Work Order ID 115786

Item Name: Fwd Crosstube - High

DRAWING NO. D212-664-141	TITLE XTUBE ASSY (205/212/412 HI FWD)	REV. D	DART AEROSPACE LTD ENGINEERING ORDER		D.E.O. NO. D212-664-141-D-1	SHEET NO. SHEET 1 OF 2	SCALE NTS
DRAWN	CHECKED	OP	MFG. APPR.	BE	APPROVED	WAP	DE APPR.
DATE 11.04.07	DATE 11.04.11		DATE 11.04.12		DATE 11/04/12		DATE 11.04.12

**D212-664-141/-141B
ASSEMBLY DETAIL**

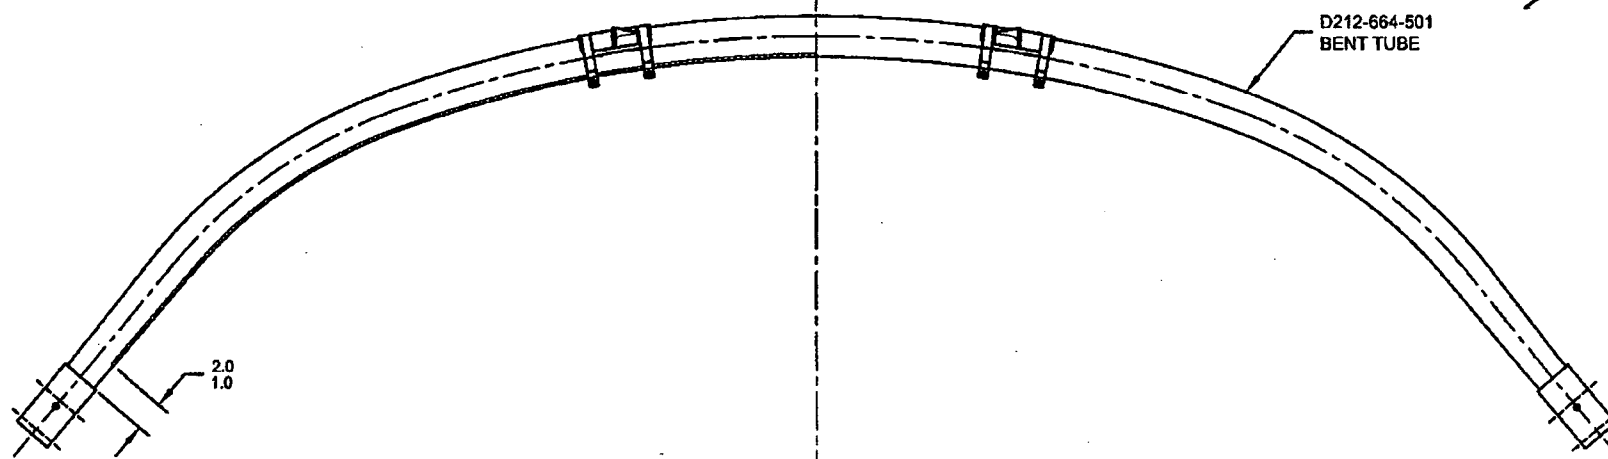
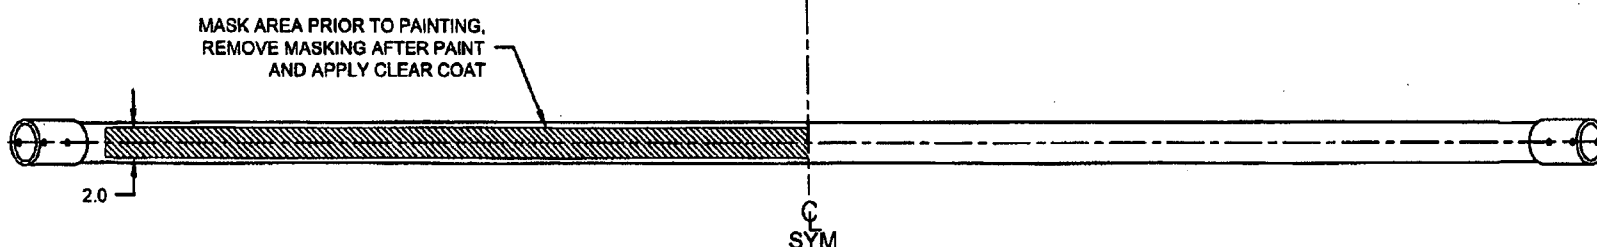
ADD AN INSPECTION WINDOW TO UNDERSIDE OF CROSSTUBE.

NOTES 2 OF SHEET 1 IS AMENDED AS FOLLOWS:

- 2) FINISH: CHEMICAL CONVERSION COAT PER DART QSI 005 4.1
PRIME INSIDE AND OUTSIDE PER DART QSI 005 4.2
MASK UNDERSIDE OF CROSSTUBE AS SHOWN (HATCHED AREA) AND
PAINT OUTSIDE PER DART QSI 005 4.2
REMOVE MASKING AND APPLY CLEAR COAT
